Micro Control Systems

APPLICATION NOTE
APP-029

MCS-8 & MCS-I/O Modifications to make Rev. 1.565

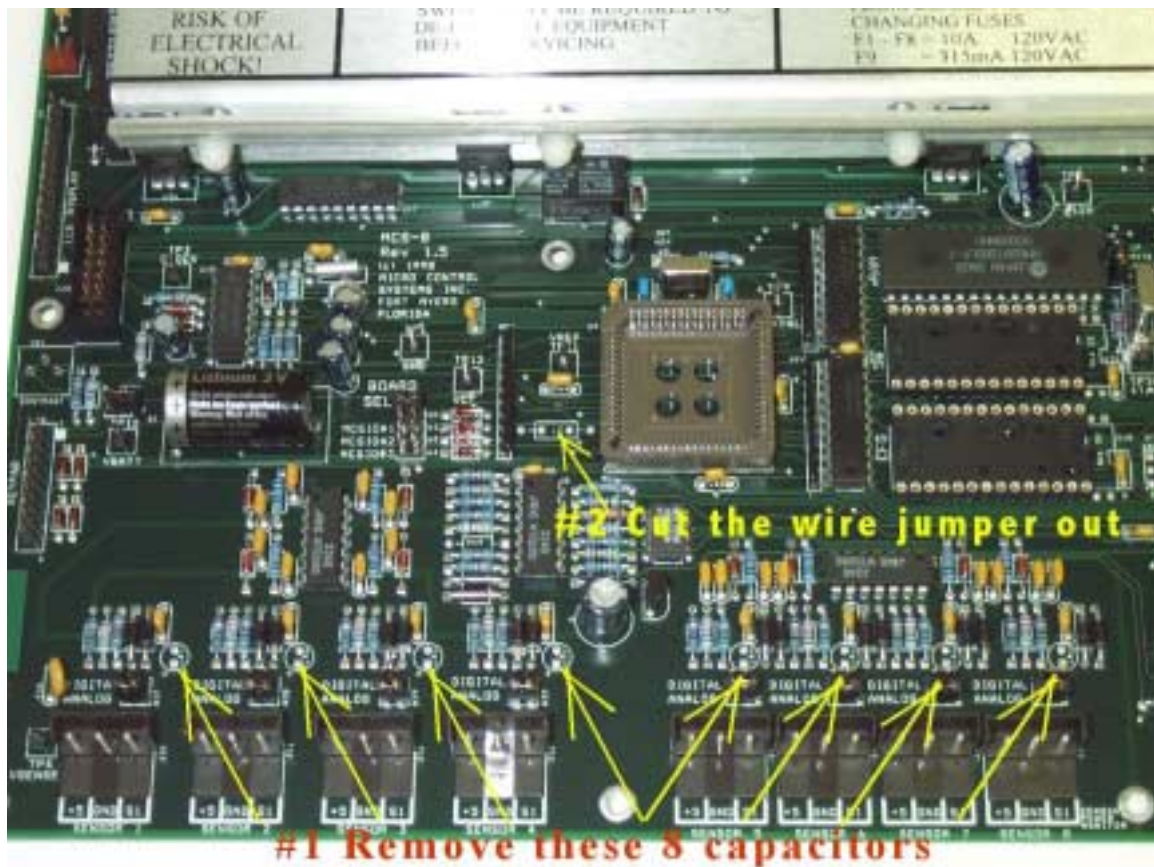
#1 Remove the 8 electrolytic capacitors in locations: C47, C48, C49, C51, C60, C61, C62, and C63.

#2 Cut wire jumper in location L2.

#3 Install on the backside of board a solder bridge between pins 12 and 14 on the CPU socket U9.
